| Project            | IEEE 802.16 Broadband Wireless Access Working Group

**Figure 17—PHY Synchronization Field (PHY Type = 2)**

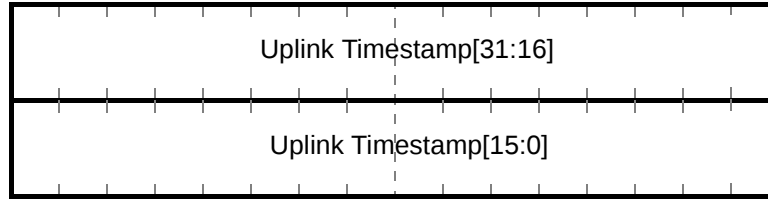
*TLVs moved to parameter section. Insert content from section 2.5.3 NEEDS to be rewritten.*

Figure 16—PHY Synchronization Field (PHY Type = {0,1})

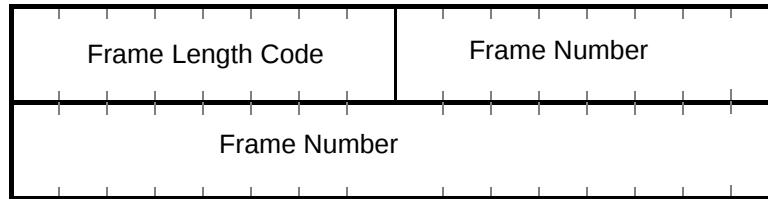
*TLV moved to parameter section. Insert content from 2.5.3 . REWRITE!*
